Submissions and Preferred Infrastructure Report

Albion Park Rail bypass

SUBMISSIONS AND PREFERRED INFRASTRUCTURE REPORT

Report No FCIA0001-APRB-R-13

Figure 3-1 Indicative aspirational (Code 3) obstacle limitation surface intrusions - 1

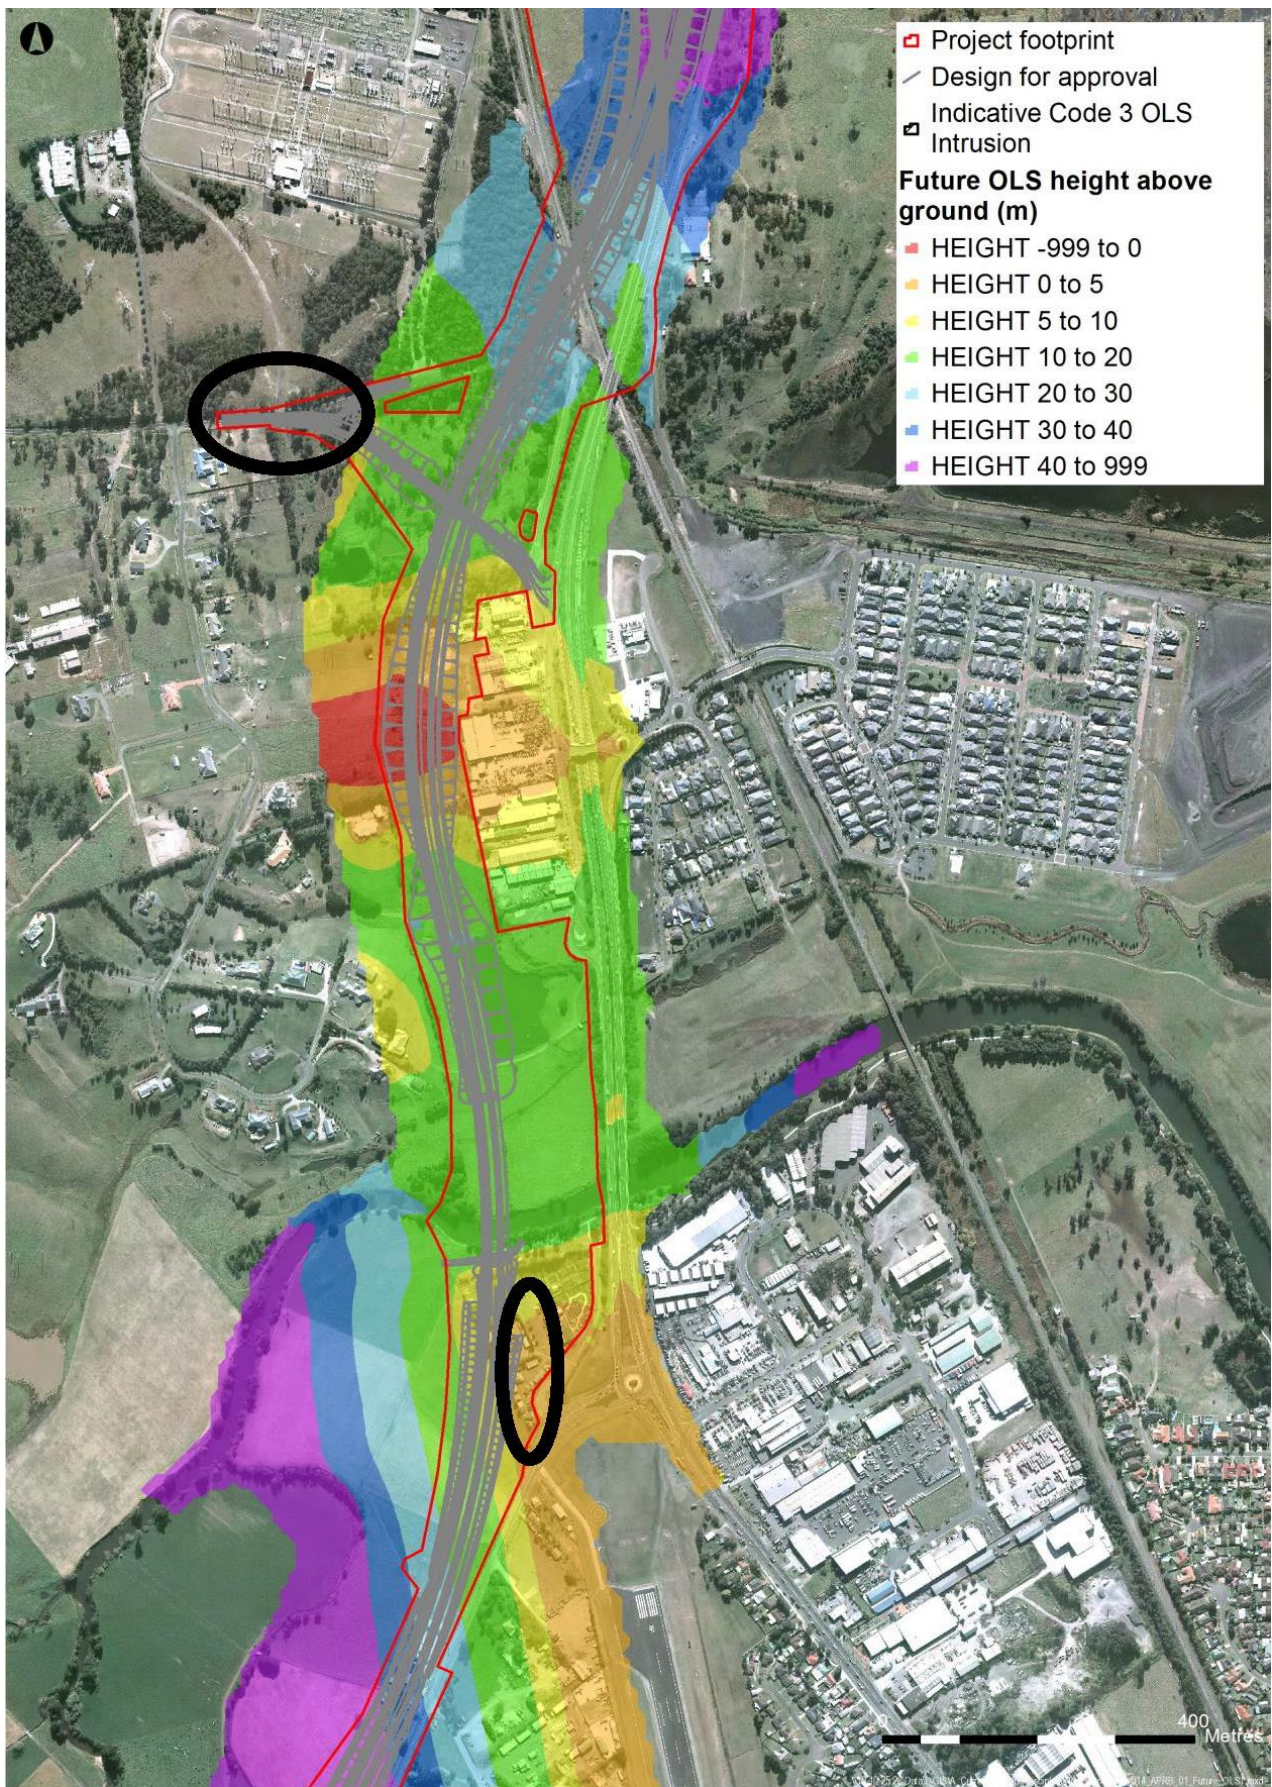
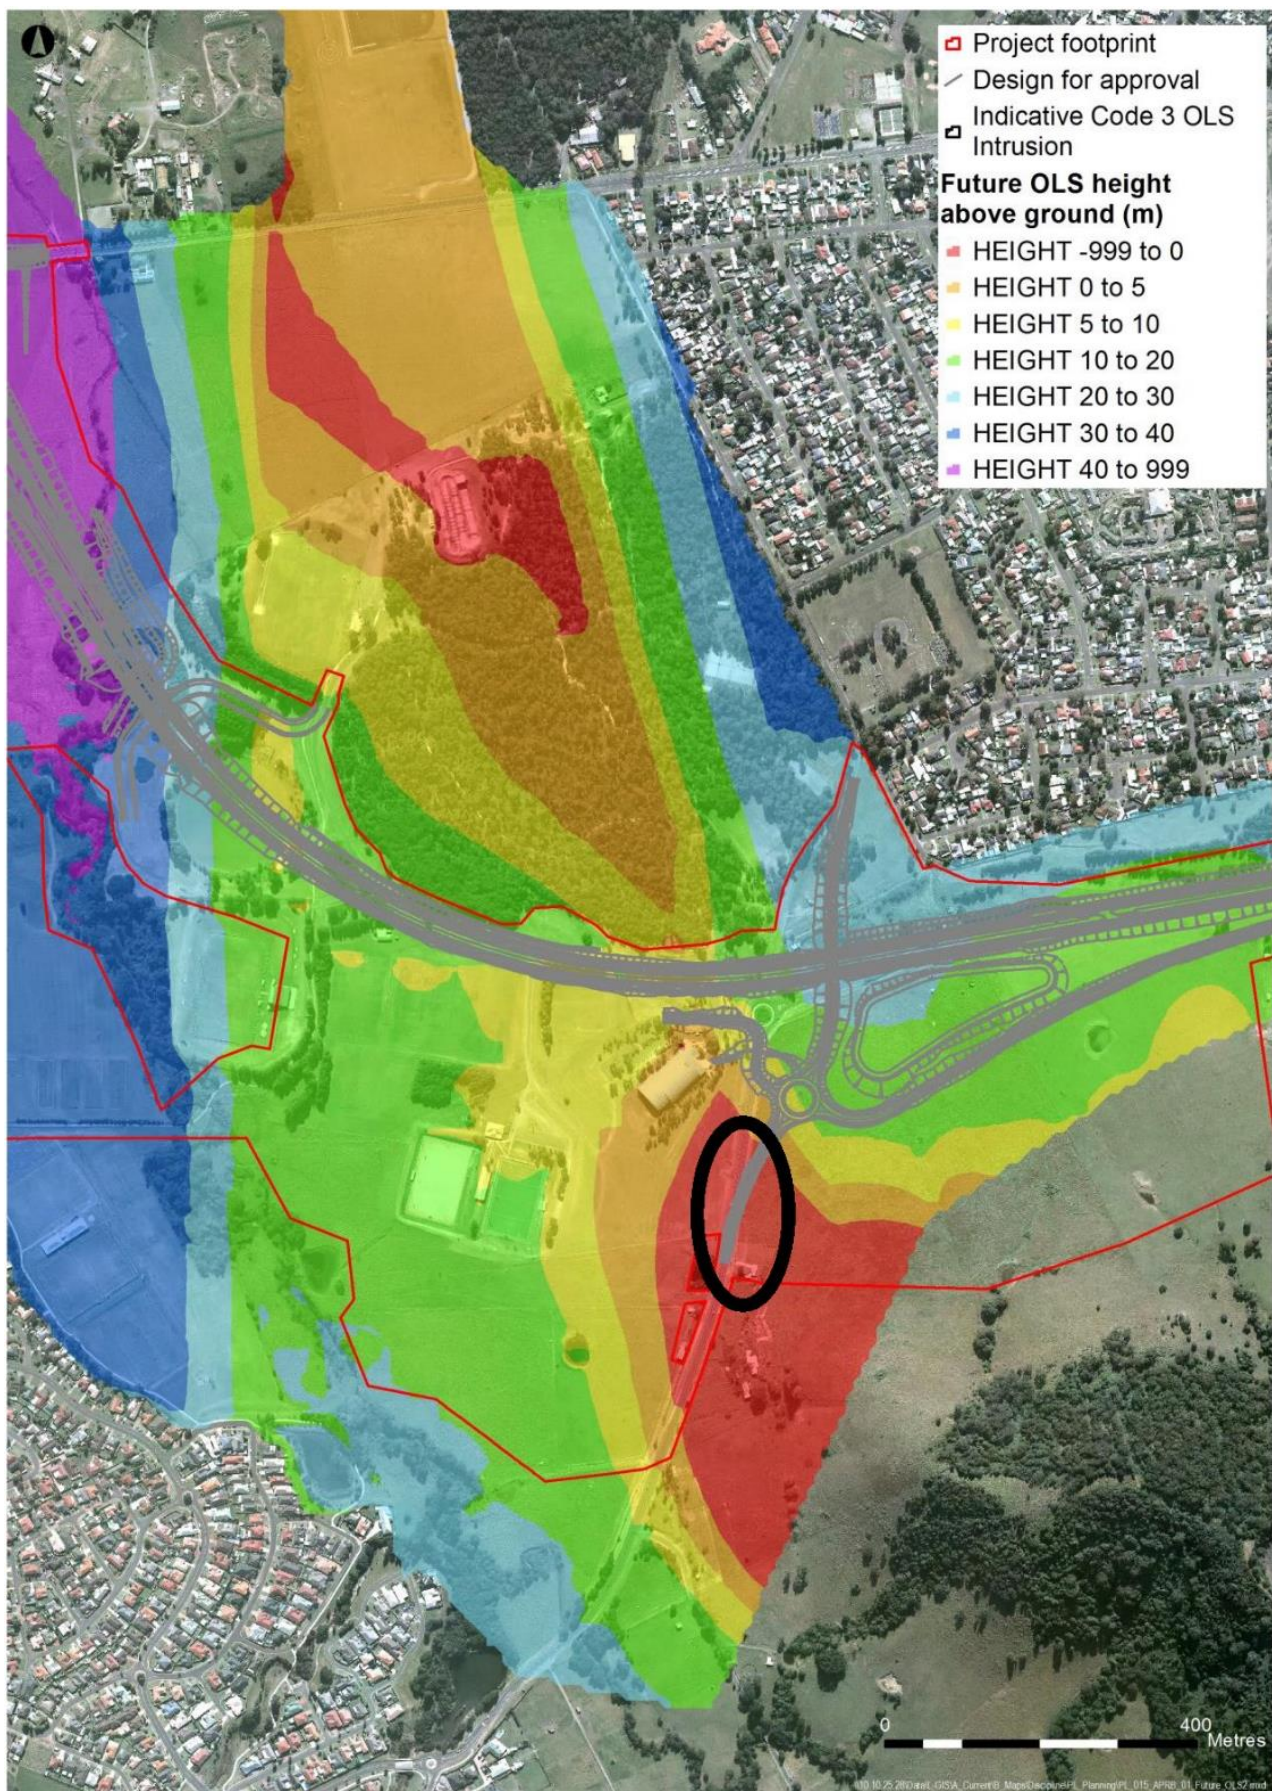
Section 4.1.1 of Technical Paper 2 – Aviation and Section 3.2 of the aviation assessment addendum (Appendix B) describes locations where the project penetrates the aspirational obstacle limitation surface. These locations are listed below and shown in Figure 3-1 and Figure 3-2:

- The Runway 16 approach surface would be infringed by a 4.6 metres vehicle envelope from a point approximately 100 metres south of the existing roundabout along the Illawarra Highway to a point approximately 35 metres to the north of this point (refer Section 3.2.2 of Appendix B).

The project would extend into the aspirational obstacle limitation surface in three areas. Two of the intrusions relate to areas where the motorway is proposed to connect with existing local roads that already intrude into the aspirational obstacle limitation surface. In these locations, the project would not result in a greater penetration than currently occurs. The third intrusion would only occur when a 4.6 metre high vehicle parks in an 80 metre section on the southbound shoulder of the motorway. This area will be marked as no stopping to ensure that it remains free on any intrusions on the aspirational obstacle limitation surface (management measure TT06).

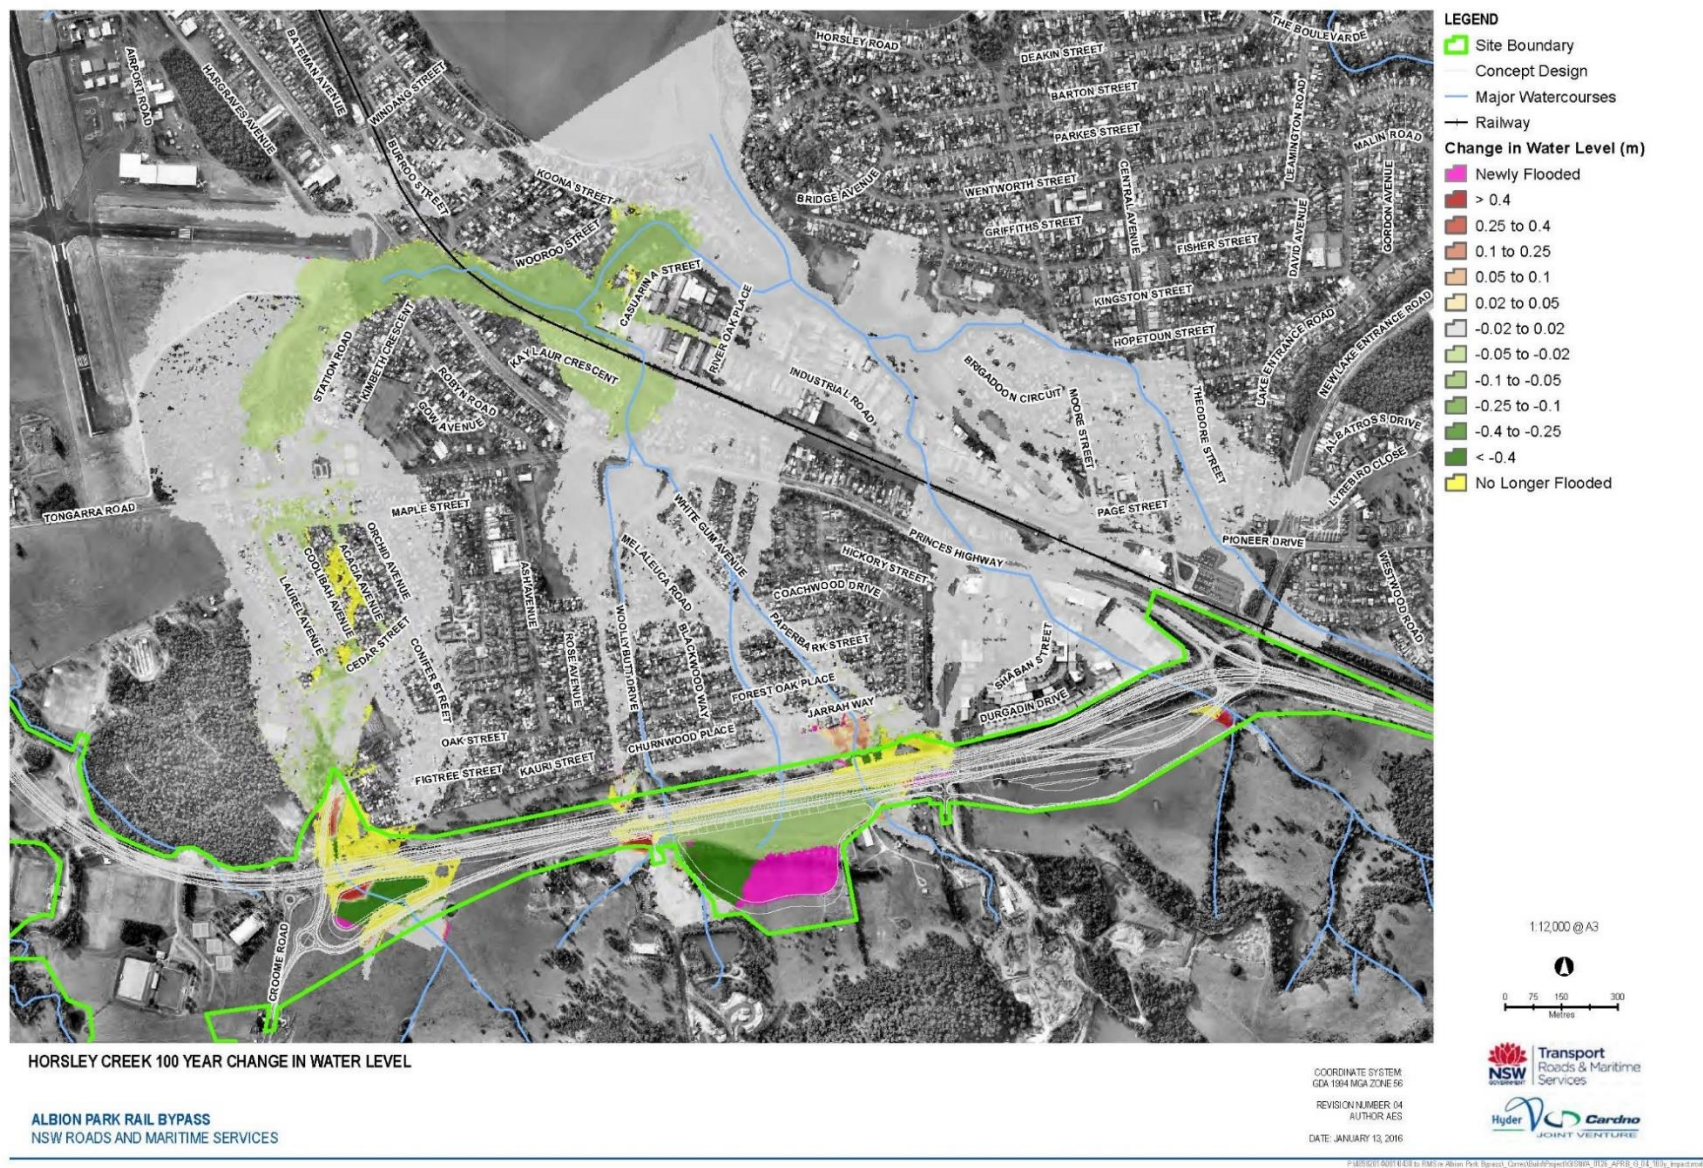
Figure 6-6 of Technical Paper 3 – Hydrology and Flooding identified the impacts of the project on flooding of agricultural and recreational land in the Horsley Creek catchment in the 100 year ARI event (Figure 4-1). It is noted that this figure is incorrect due to an error in the legend that failed to identify areas that would become flood free in the 100 year ARI (shown in yellow).

The figure has been updated and is provided below in Figure 4-2. A total of 23 properties in Albion Park Rail would become flood free in the 100 year ARI event as a result of the project due to the provision of a new detention basin near Croome Road.

Figure 4-5 An example of vegetation incorrectly faded in the landscape concept plans

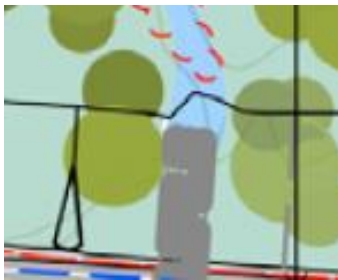
Within the drawings some of the proposed tree plantings were faded as part of the design process which resulted in difficulty in differentiating between existing and proposed vegetation. An example of proposed trees appearing to look like existing vegetation is included in Figure 4-5.

The latest landscape concept designs, included in Appendix I of this report, has rectified this issue allowing for a clear differentiation between proposed and existing vegetation.

Figure 5-8 Interchange alignment at Albion Park

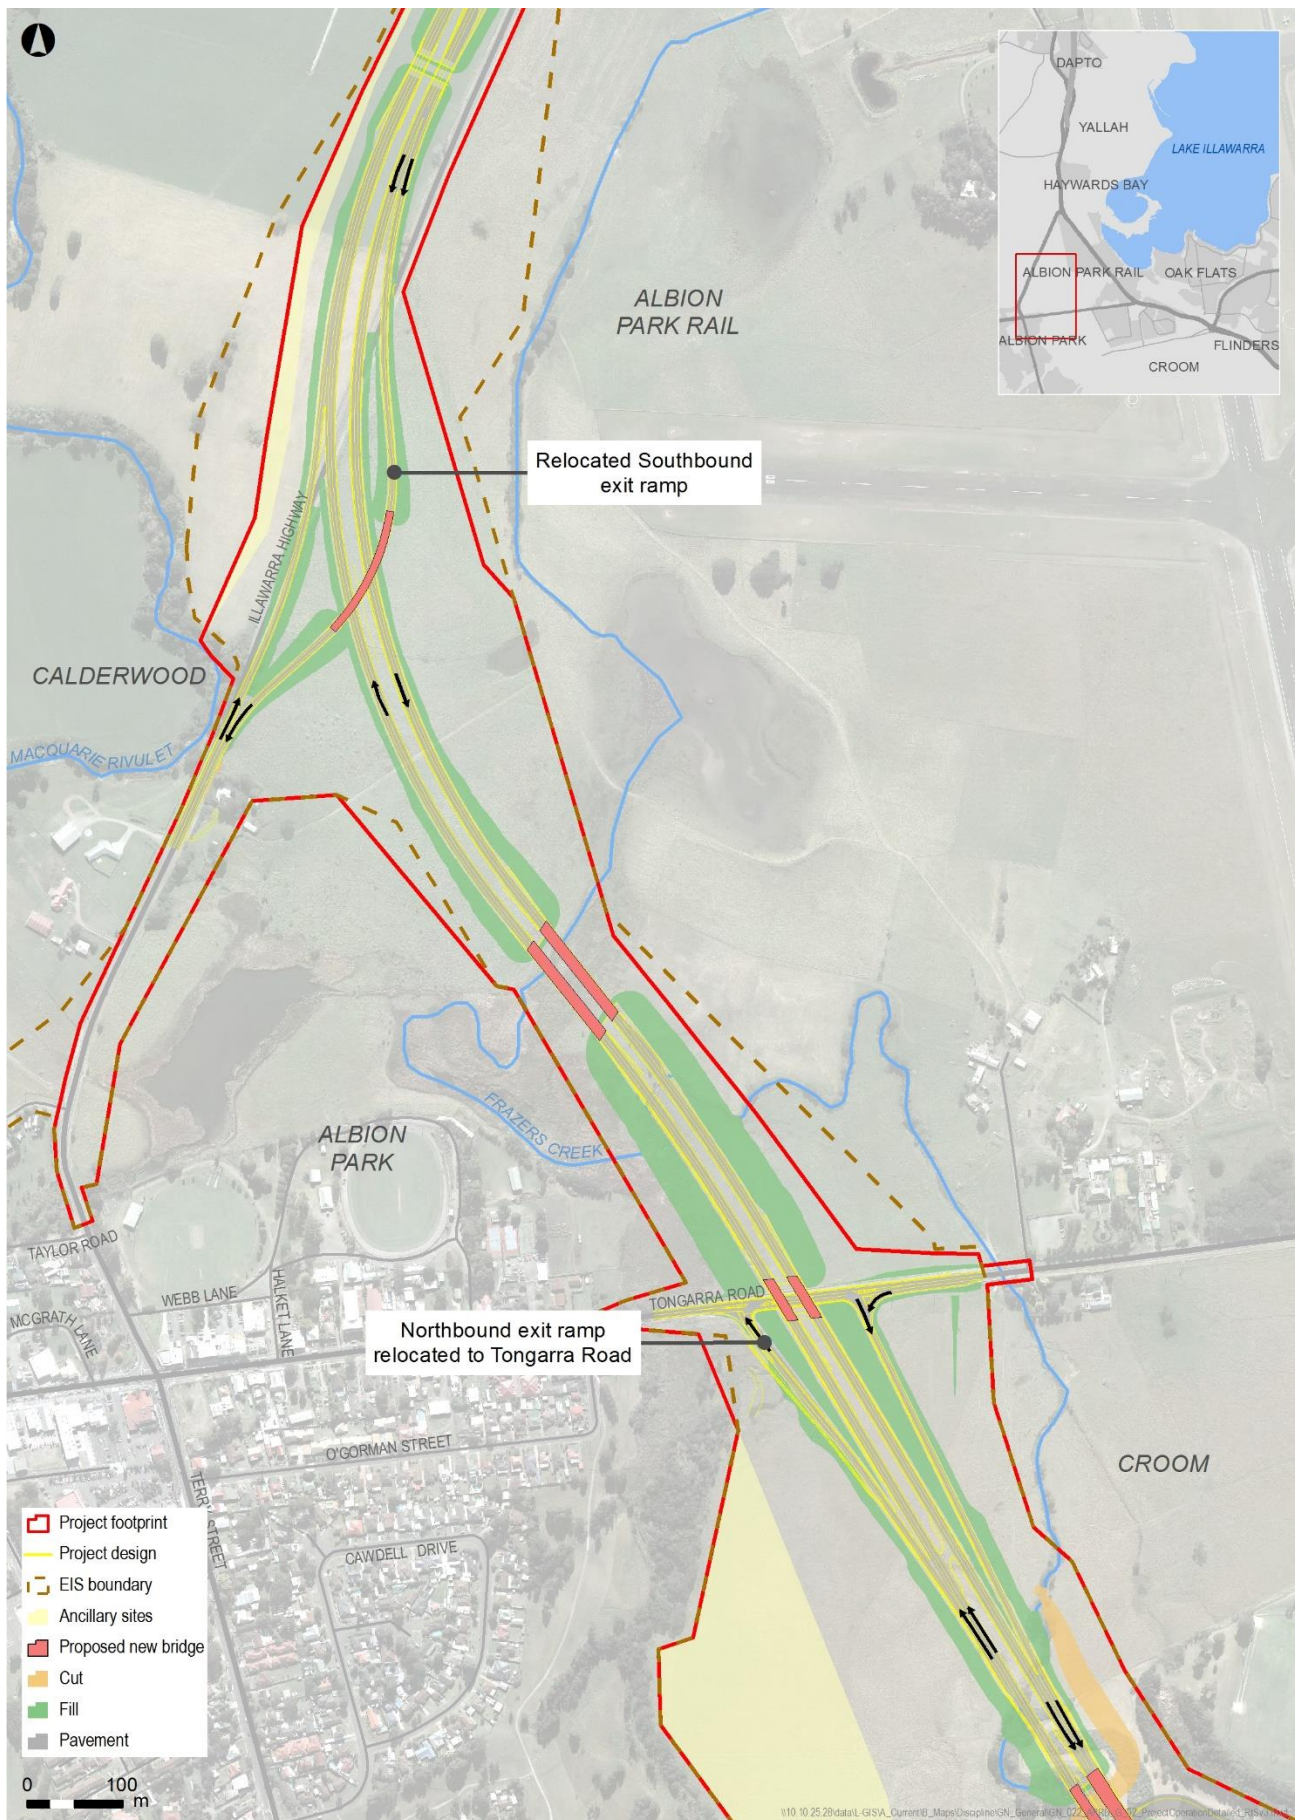
Due to concerns raised in submissions regarding the impact on agricultural lands, Roads and Maritime identified the need to review the design in order to reduce these impacts. Additional design development was undertaken for the interchange at Albion Park and a change to the preferred interchange arrangement was identified and is described below and shown in Figure 5-8. The proposed changes to the interchange are designed to allow connection to a future bypass of Albion Park (Tripoli Way).

- An additional signalised intersection would be provided to allow connection of the northbound exit ramp to Tongarra Road. Entry onto the southbound on ramp would also be signalised.

Tongarra Road would be upgraded as described in the environmental impact statement, and the Illawarra Highway (north of Croome Lane) and Terry Street would be changed as described in the environmental impact statement (see Figure 5-8).
